SERVICE PROCEDURE

**26509
July 2026**

SUBJECT: SAFETY RECALL

**Brake timing in certain 2026 and 2027
International® HV™ Series trucks built 07/01/2025
thru 04/16/2026 with the following unique
configurations (feature codes):**

Figure 1. Fitting Locations

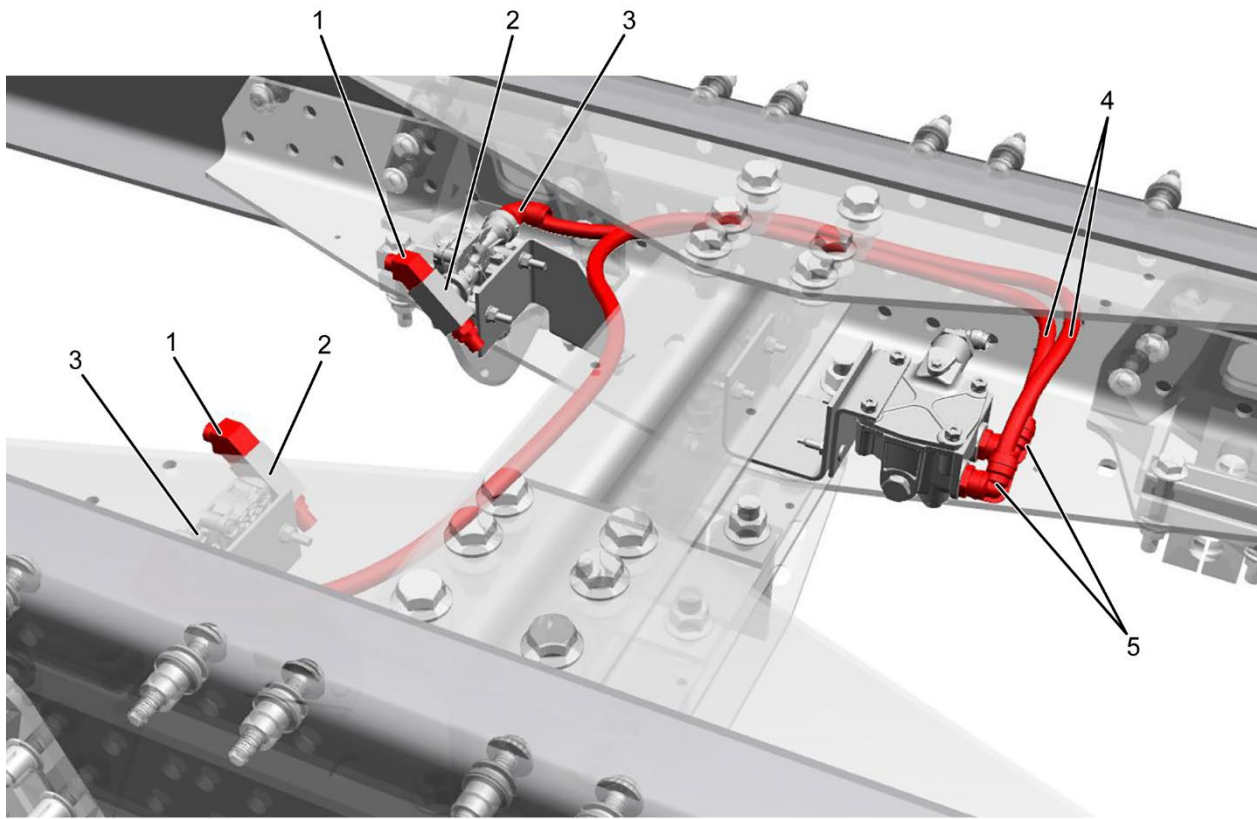
Certain International® HV™ Series trucks with a walking beam with multi-leaf suspension and 4-channel ABS do not meet FMVSS-121 S5.3.4 brake release timing requirement. Each service brake system shall meet the requirements of S5.3.4.1 (a).

S5.3.4.1 (a) With an initial service brake chamber air pressure of 95 psi, the air pressure in each brake chamber shall, when measured from the first movement of the service brake control, fall to 5 psi in not more than 0.55 seconds.

6. Starting on the driver-side, remove the 5/8-inch air line from the relay valve to the modulator valve (Figure 1, Item 4).
7. At the relay valve, remove the 5/8-inch 90-degree elbow and install the 3/4-inch 90-degree elbow. (Figure 1, Item 5).
8. At the modulator valve, remove the 5/8-inch 90-degree elbow and install the 3/4-inch 90-degree elbow. (Figure 1, Item 3).

9. Using the 5/8-inch air line that was removed as a template, cut a section of 3/4-inch air line to the same length.
10. Install air line into fittings that were replaced.
11. Repeat Steps 5 through 10 for the passenger-side of the vehicle.
